March 14, 1983

Subject: Calvert Cliffs Nuclear Power Plant  
Units Nos. 1 & 2; Dockets Nos. 50-317 and 50-318  
TMI Action Plan, Items II.F.1.4, 5, & 6  
Post-Implementation Review

**CALVERT CLIFFS NUCLEAR POWER PLANT  
RESPONSE TO REQUEST FOR ADDITIONAL INFORMATION  
IN REGARD TO TMI ACTION PLAN ITEM II.F.1**

PRESSURE MONITORING SYSTEM

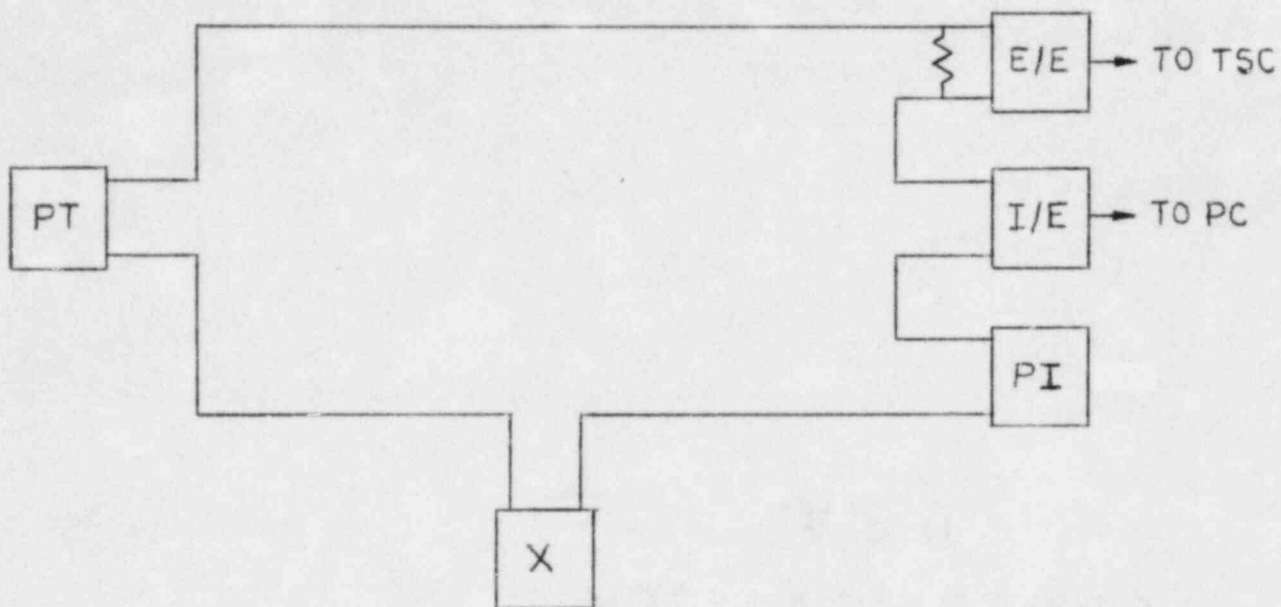
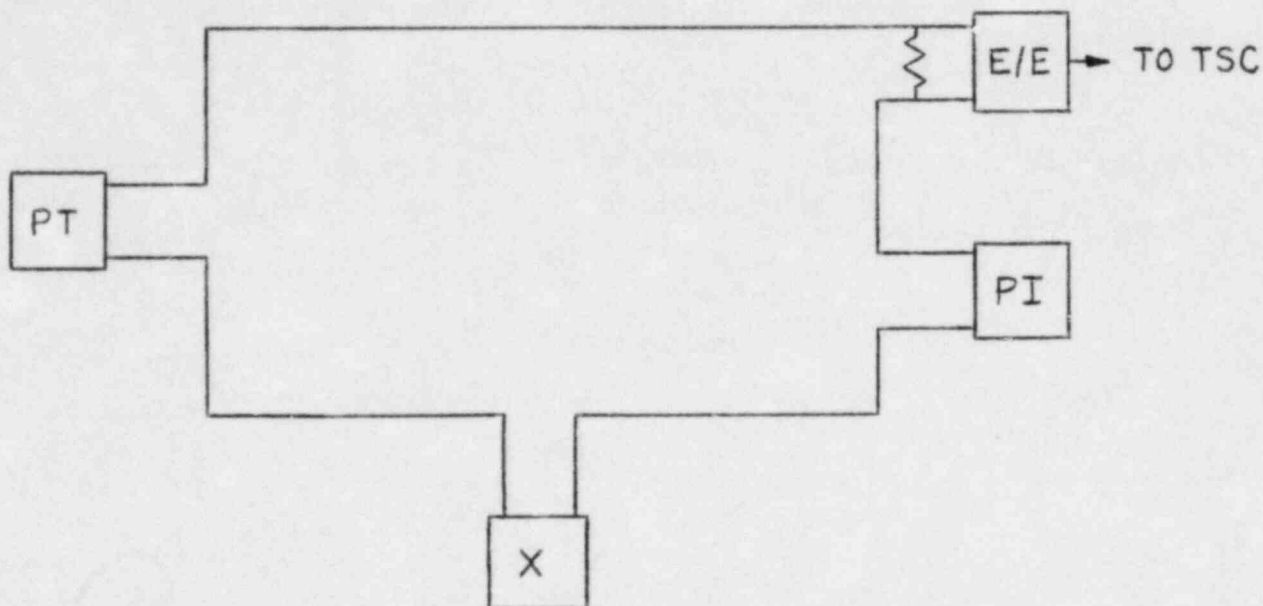
Question: (2a) Provide a block diagram of the configuration of modules that make up your PMS. Provide an explanation of any details in the block diagram that might be necessary for an understanding of your PMS accuracy and time response.

Question: (2b) For each module provide a list of all parameters which describe the overall uncertainty in the transfer function of the module.

Question: (2c) Combine parameters in 2b to get an overall system uncertainty. If you have both strip chart recorder and indicator output, give the overall system uncertainty for both systems. If you have systems spanning different ranges, give the overall system uncertainty for each system.

Question: (2d) For each module indicate the time response. For modules with a linear transfer function, state either the time constant,  $\tau$ , or the Ramp Asymptotic Delay Time, RADT.

Response: Refer to Figure 1 for the block diagram and uncertainty parameters for the containment pressure monitoring system.

Response: The total maximum uncertainty for channel A is  $\pm 1.8\%$  and for channel B is  $\pm 1.2\%$  under normal operating conditions.

Response: The time responses for the modules are listed below:

Channel A

ITT Barton Transmitter - 180 msec for 10% to 90% of step function.  
Sigma Meter - 2 second nominal full scale response

Channel B

Fischer and Porter transmitters - first order step response time is .03 second.  
Sigma Meters - 2 second nominal full scale response

FIGURE 2

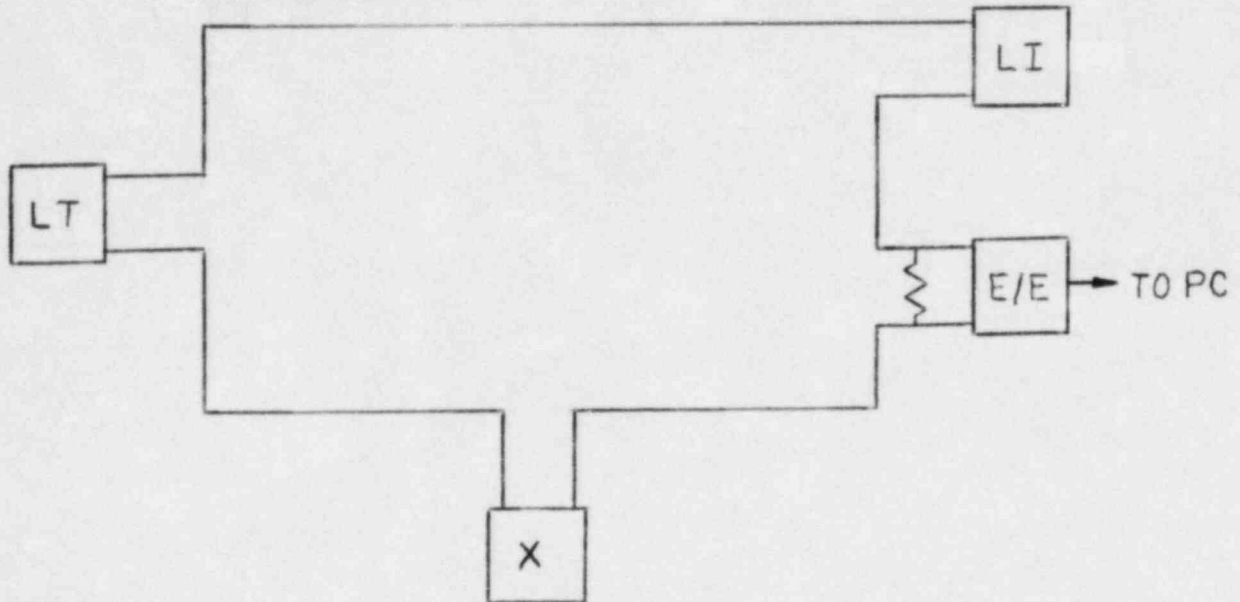
Question: (3a) Provide a block diagram of the configuration of modules that make up your WLMS. Provide an explanation of any details in the block diagram that might be necessary for an understanding of your WLMS accuracy.

Question: (3b) For each module provide a list of all parameters which describe the overall uncertainty in the transfer function of that module.

Question: (3c) Combine parameters in 3b to get an overall system uncertainty. If you have both strip chart recorder and indicator output, give the overall system uncertainty for both systems. If you have systems spanning different ranges, give the overall system uncertainty for each system.

Response: Refer to Figure 2 for the block diagram and uncertainty parameters for the containment water level monitoring system.

Response: For normal operating conditions, the total maximum system uncertainty is + 1.8%.

FIGURE 3  
HYDROGEN MONITORING SYSTEM

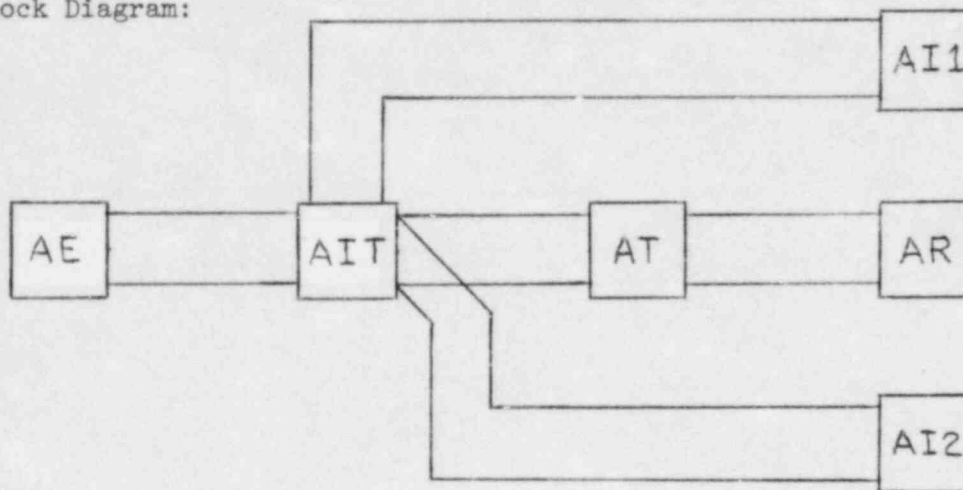
Question: (4a) Provide a block diagram of the configuration of modules that make up your HMS. Provide an explanation of any details in the block diagram that might be necessary for an understanding of your HMS accuracy. If you have different types of HMS's give this information for each type.

Question: (4b) For each module provide a list of all parameters which describe the overall uncertainty in the transfer function of that module.

Question: (4c) Combine the parameters in 4b to get an overall system uncertainty. If you have both strip chart recorder and indicator output, give the overall system uncertainty for both systems.

Response: Refer to Figure 3 for the block diagram and uncertainty parameters for the containment hydrogen monitoring system.

Response: The total maximum system uncertainty for the indicator loop is  $\pm 3.2\%$  and for the strip chart recorder loop is  $\pm 2.5\%$  under normal conditions.
